Access Compliance Report

Public Rights-of-Way

Intersection ID: 43935	Main Street: TRELLIS_POINTE_BV	Cross Street: CIRCUMFERENTIAL_RD	Location: S
ADA ID: 2C00E67E030B	Ramp Type: PerpDiag	Initial Pass/Fail: Fail	Overall Compliance: No
Severity Score: 8.75			
Codes/Mitigation Info/Possible Solution		Field Measurements/Component Compliance

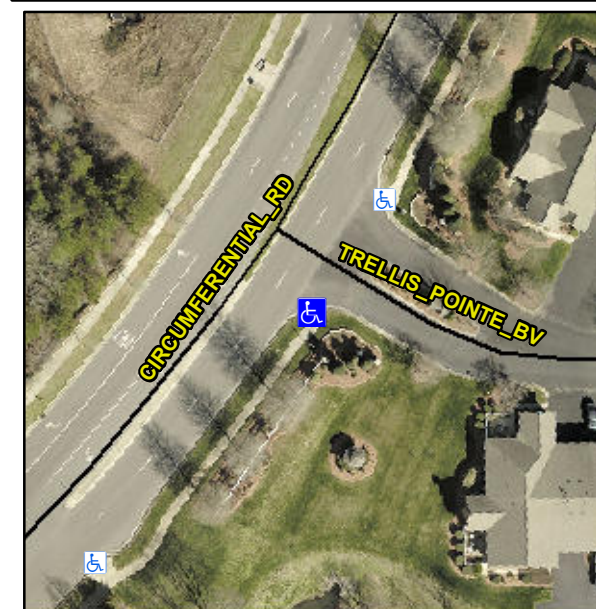
N/A

Compliance	Description	Data	Compliance	Description	Data
N/A	Ramp Length (in)	90.0	Yes	Ramp Slope (%)	7.2
No	Ramp Width (in)	46.0	Yes	Ramp XSlope (%)	2.0
N/A	Flare Type LT	N/A	N/A	Flare Type RT	N/A
N/A	Flare Slope LT (%)	N/A	N/A	Flare Slope RT (%)	N/A
N/A	Flare Traversable LT?	N/A	N/A	Flare Traversable RT?	N/A
N/A	Landing Length (in)	N/A	N/A	DWS Provided?	N/A
N/A	Landing Width (in)	N/A	N/A	DWS Contrast?	N/A
N/A	Landing Slope (%)	N/A	N/A	DWS Length (in)	N/A
N/A	Landing X Slope (%)	N/A	N/A	DWS Full Width?	N/A
N/A	Landing Curb? (Y/N)	N/A	N/A	DWS Offset (in)	N/A
N/A	Shared Landing?	N/A			
N/A	Gutter Ponding?	N/A	N/A	Gutter Slope (%)	N/A
N/A	Gutter Lip Ht (in)	N/A	N/A	Gutter X Slope (%)	N/A
N/A	Painted X Walk1?	No	N/A	Painted X Walk2?	No
	X Walk 1 Direction	To NE		X Walk 2 Direction	To NW
N/A	X Walk 1 Width (in)	N/A	N/A	X Walk 2 Width (in)	N/A
	X Walk 1 Slope (%)	4.0		X Walk 2 Slope (%)	0.4
	X Walk 1 X Slope (%)	0.1		X Walk 2 X Slope (%)	1.9

Remove & Replace Curb Ramp With Two New Directional Ramps or Equivalent.
